CONDITION 6 SURFACE WATER

Project:
PROFILE PARK POWER PLANT

Title:
PROPOSED SITE DRAINAGE

Drawing No.: 11069-2036 P05

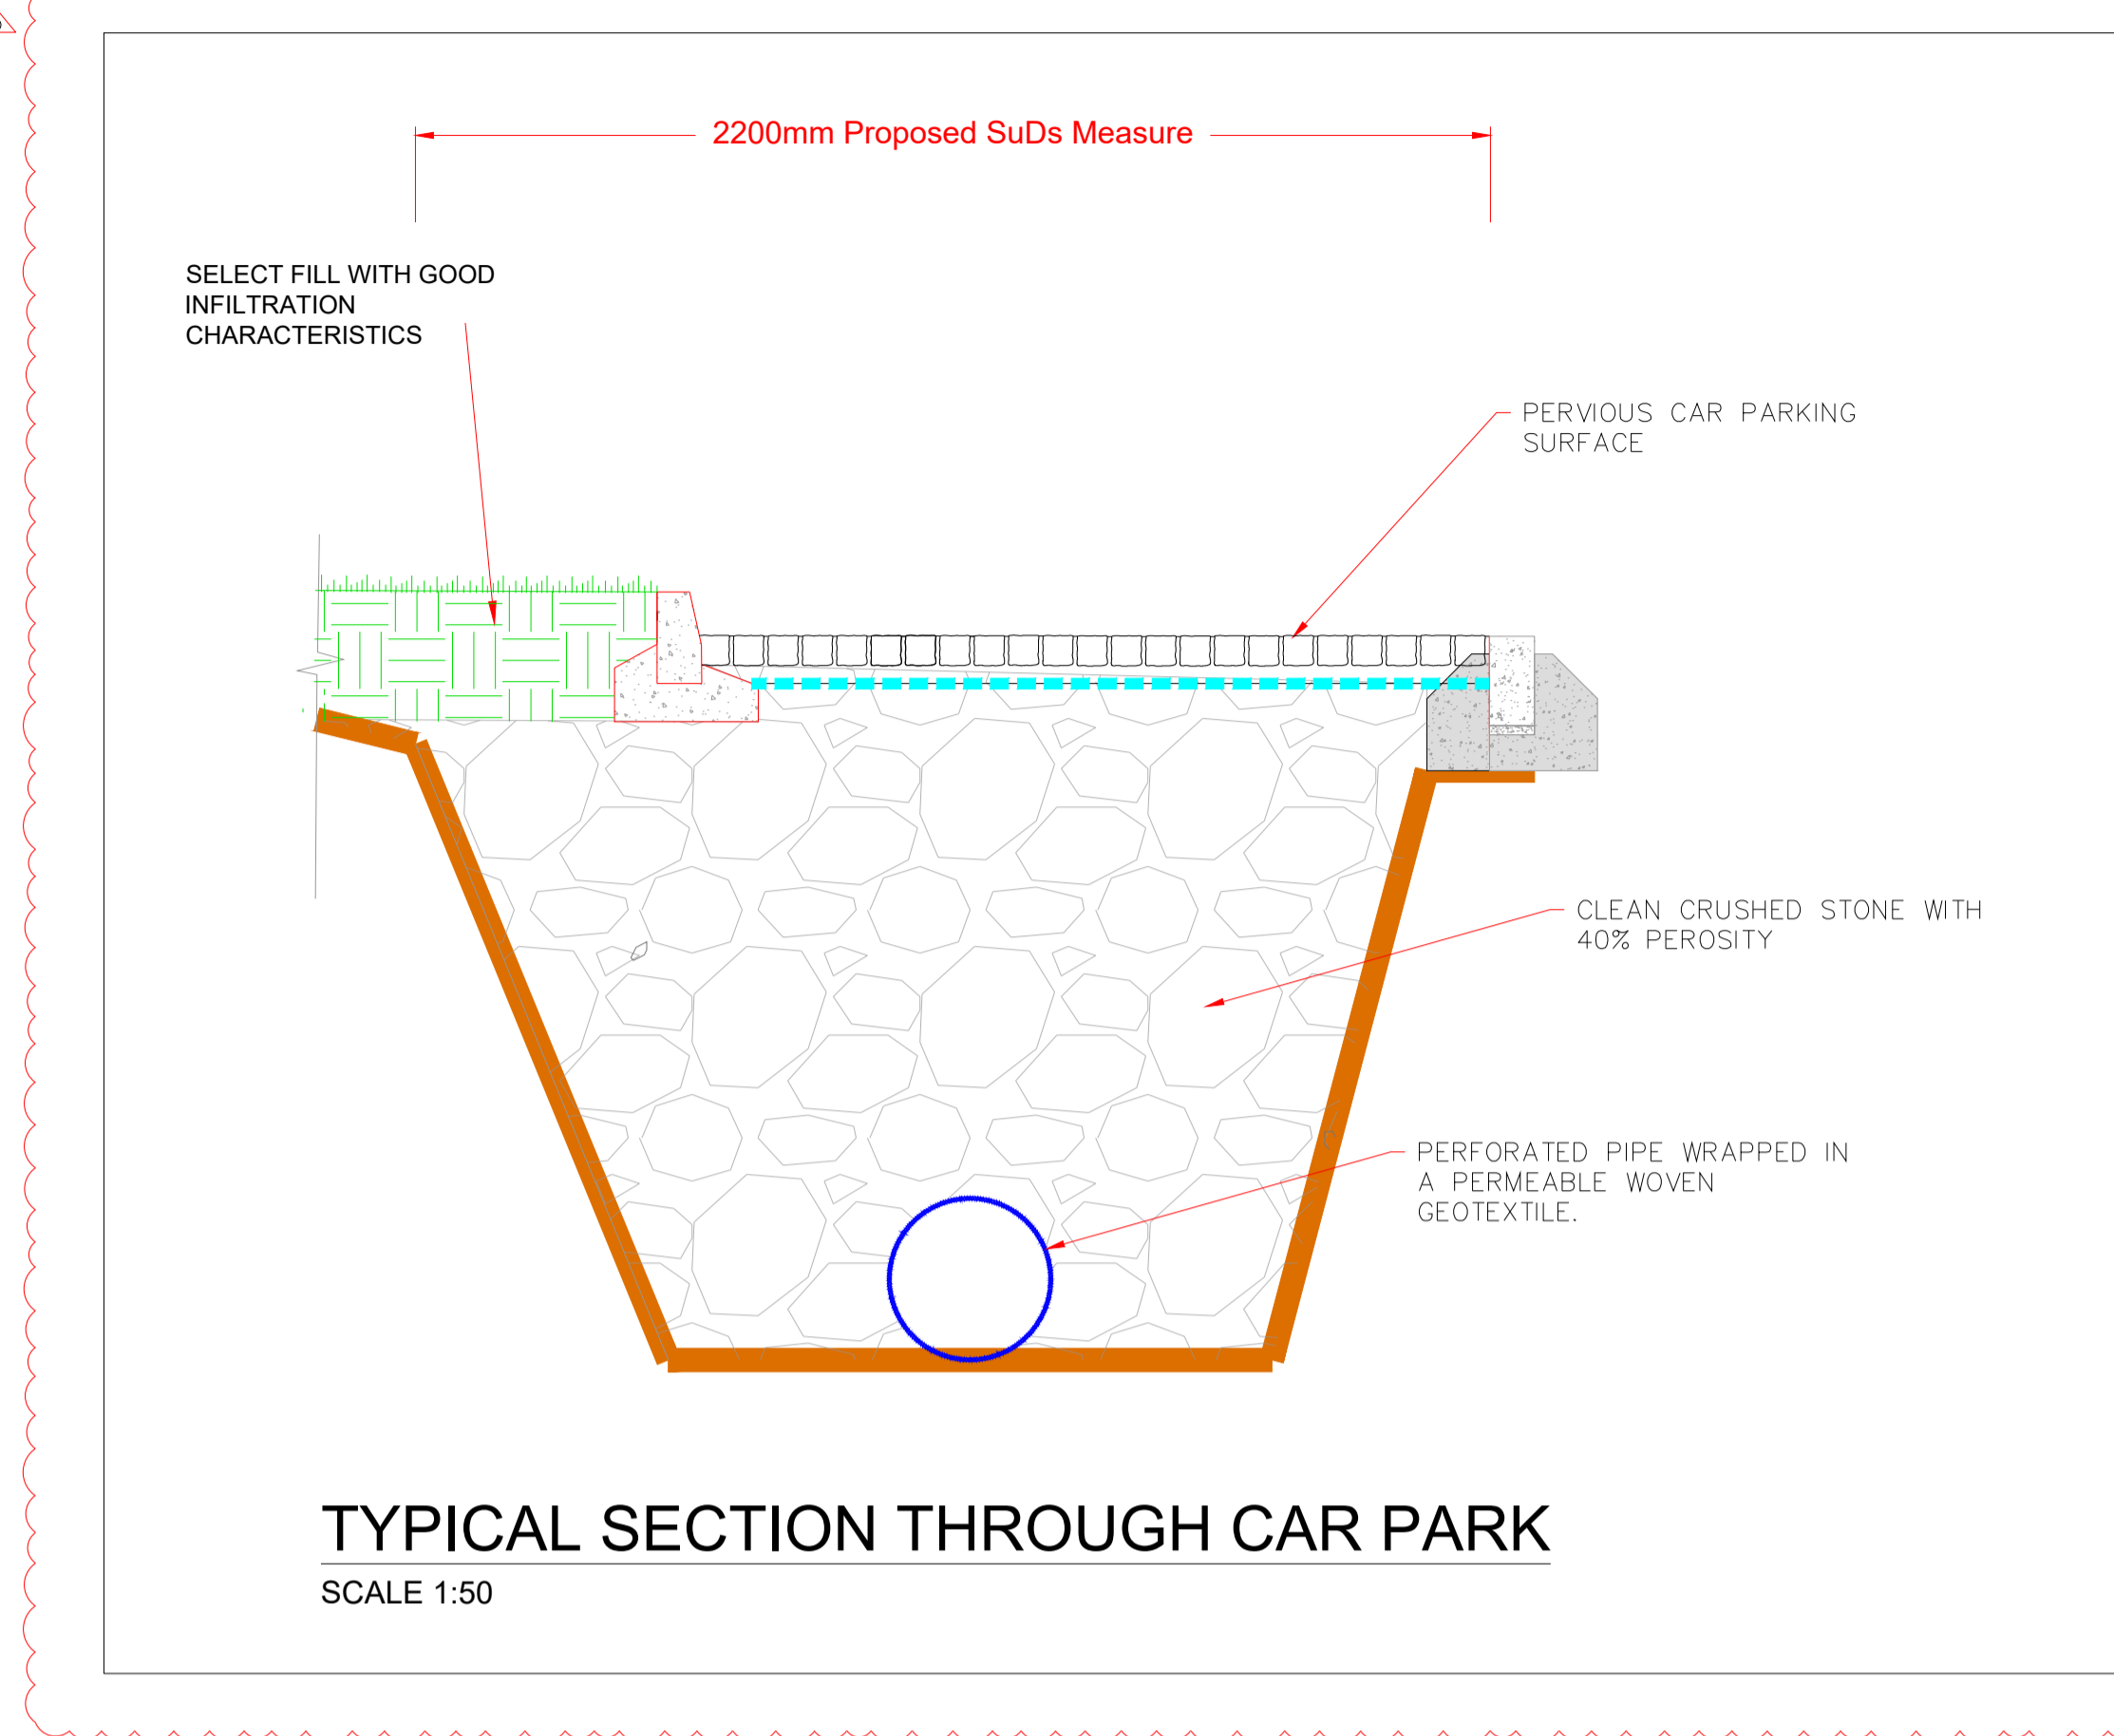
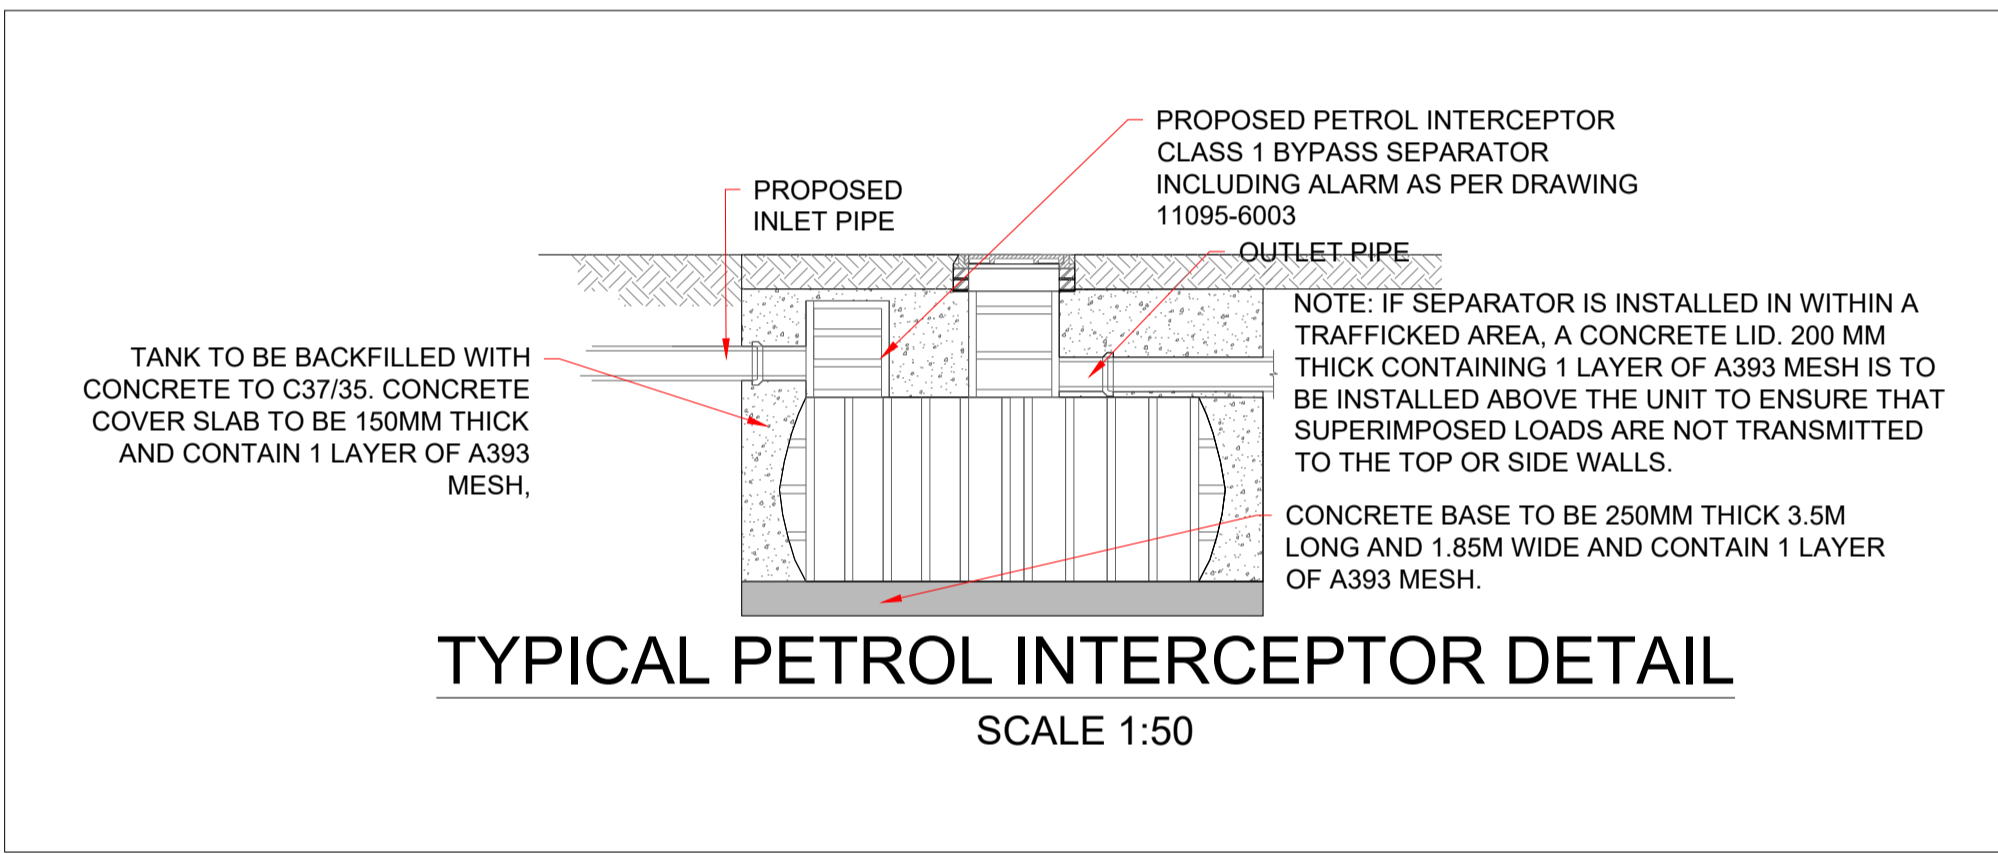
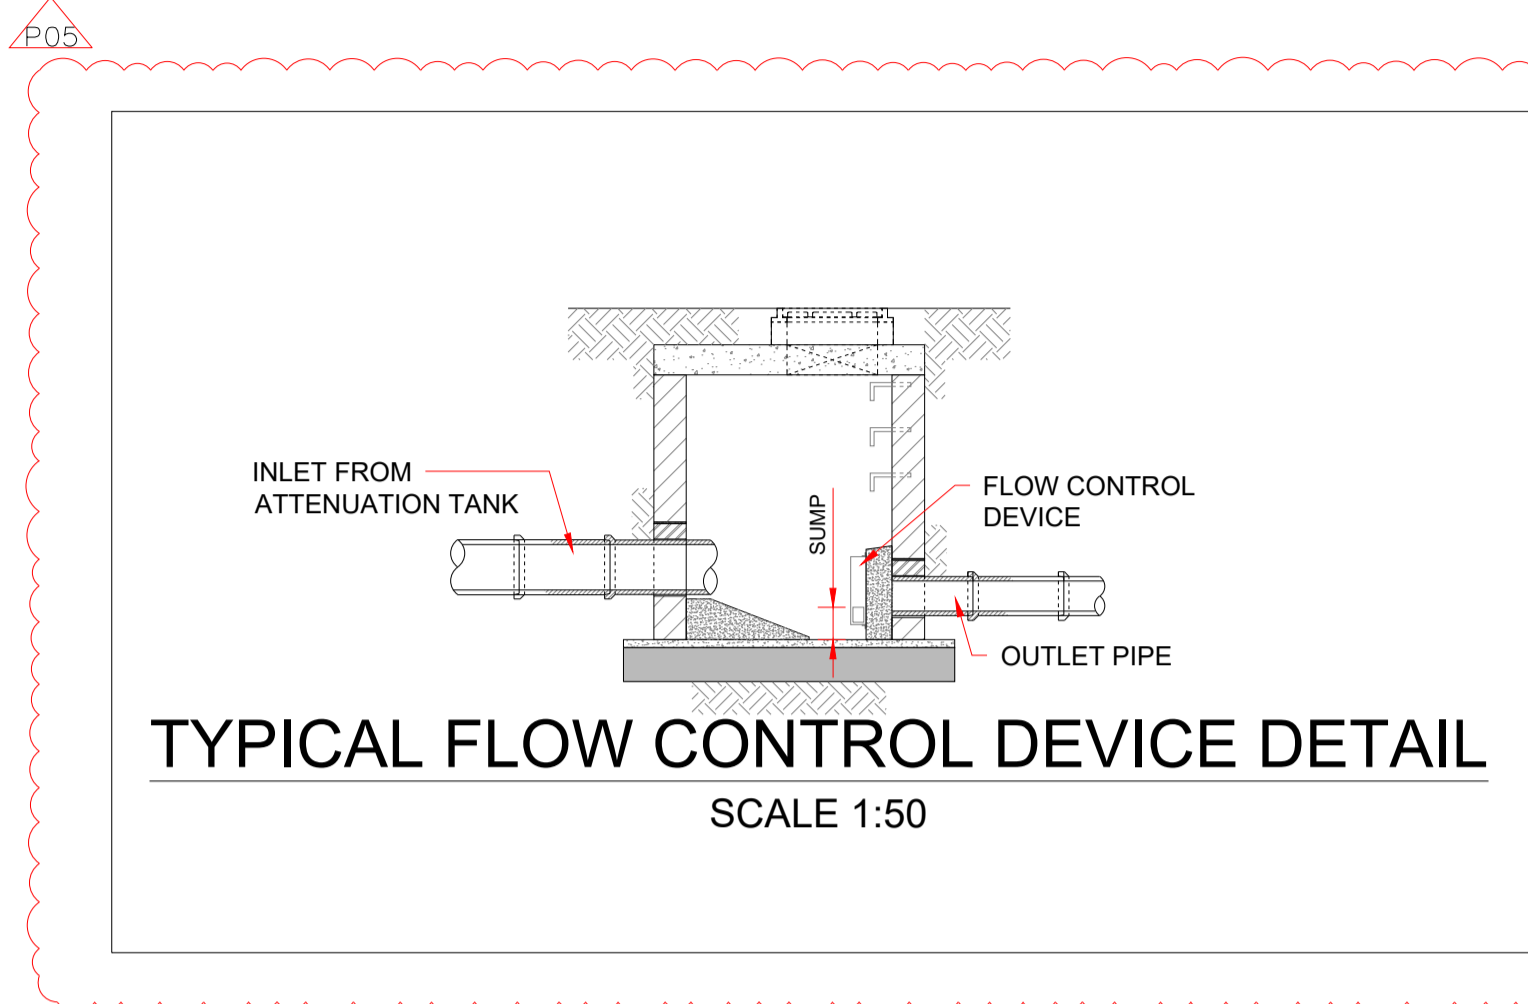
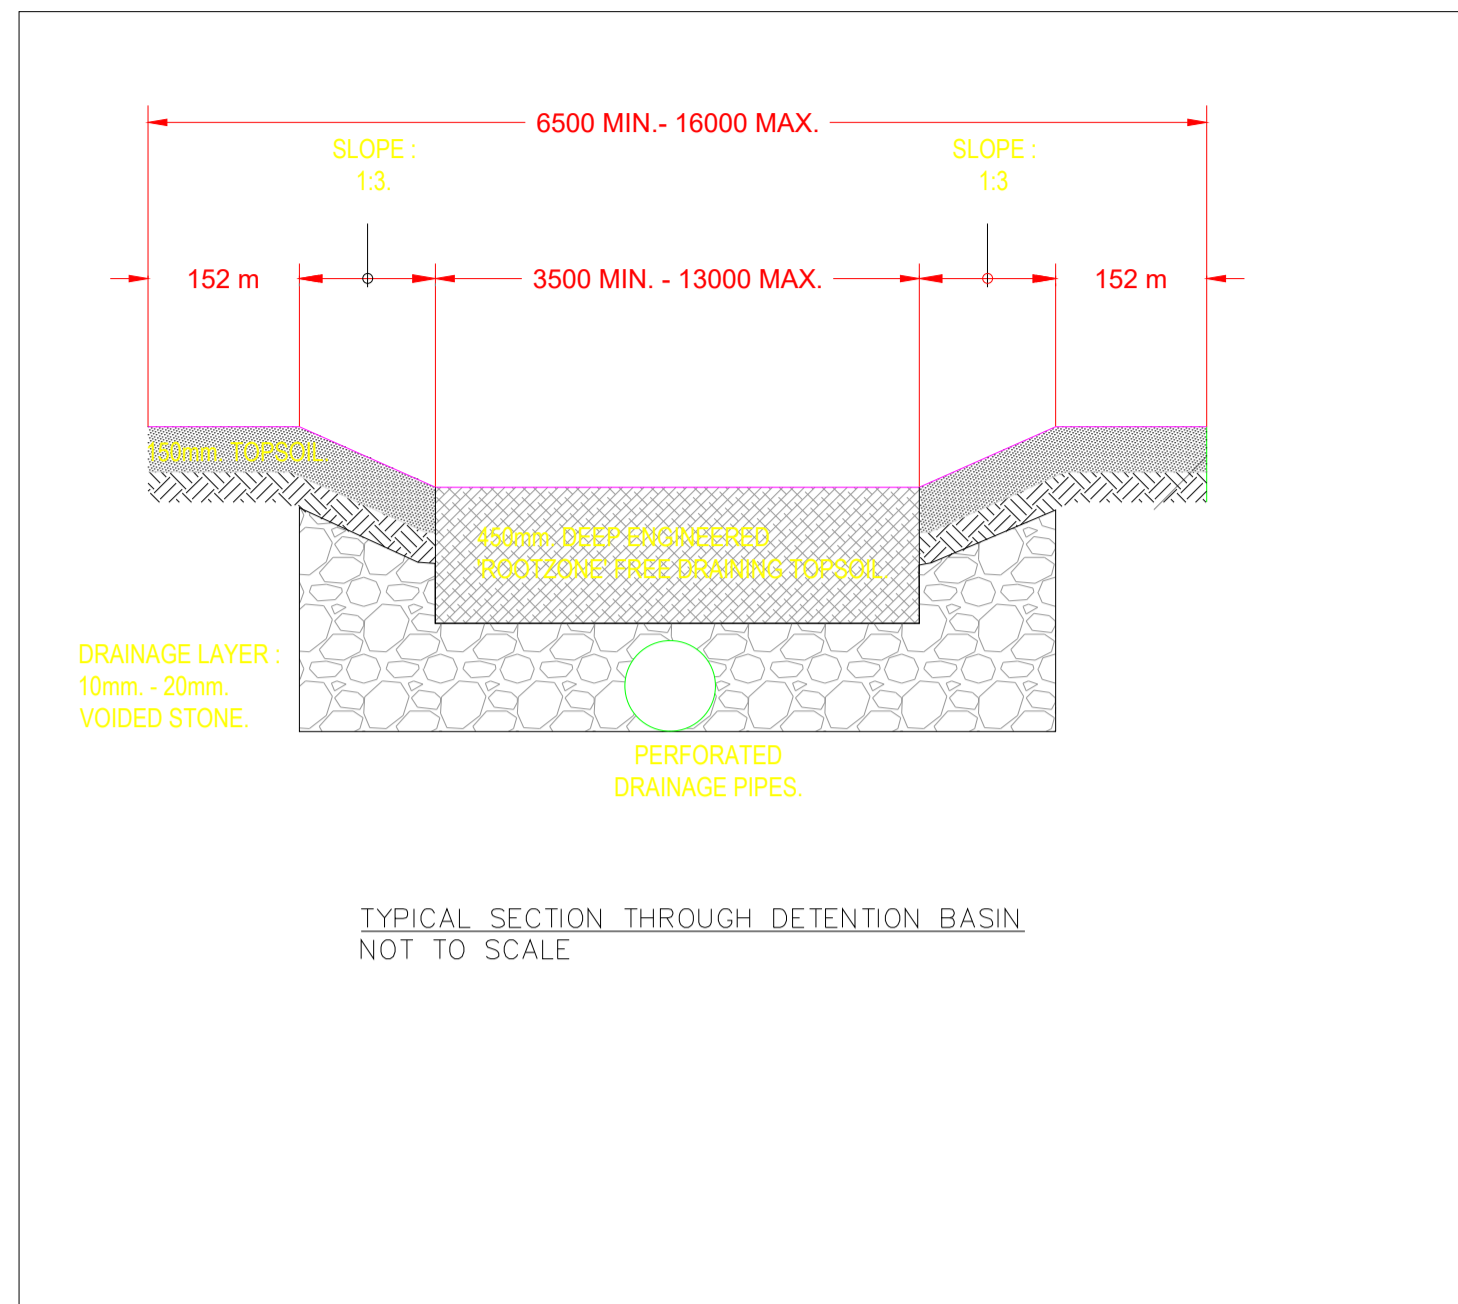
(b) Prior to the commencement of development, the applicant shall submit revised drawings which provide adequate SuDS and omit the underground attenuation and petrol interceptors, unless otherwise agreed in writing by the Planning Authority.

The originally proposed underground attenuation tank has now been omitted from the design and replaced with a cleaned crushed stone detention basin to allow for storage of surface water runoff, treatment and infiltration of stored water into the groundwater. Please refer to the enclosed updated plan no.s 11069-2010_P04 and 11069_2036_P05.
